Peyton Estates Unit Eight

City of El Paso — City Plan Commission — 4/18/2019 SUSU19-00018 — Major Combination

Re: Peyton Estates Unit Eight Combination Plat: 5-Day Review ETJ Modifications (Code # 19.04.170, A3, Alternative Subdivision Improvement Design)

RESIDENTIAL SUB-COLLECTOR (54' RIGHT-OF-WAY)

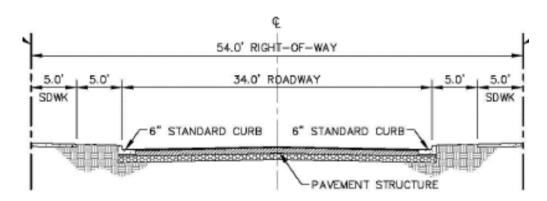
- The applicant is requesting the following modification requests pursuant to Section 19.04.170 of the former subdivision code:
 - 1. To allow a 54' ROW with 34' of pavement, a 5' landscape parkway and a 5' sidewalk. The applicant is proposing to decrease the pavement by 2' and increase the landscape parkway and sidewalk from 4' to 5', which exceeds the minimum DSC standards of the current code. El Paso Country concurs with the proposed cross-section.

RESIDENTIAL SUB-COLLECTOR - EMMAROSE WAY (76' RIGHT-OF-WAY)

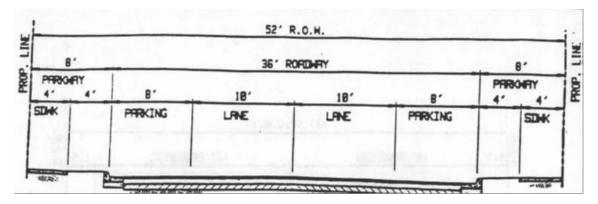
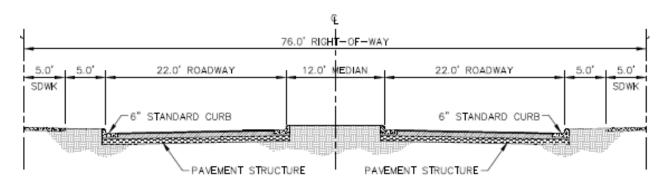
2. To allow a 76' ROW with 44' of pavement, a 12' median, a 5' landscape parkway and a 5' sidewalk, which exceeds the minimum DSC standards.
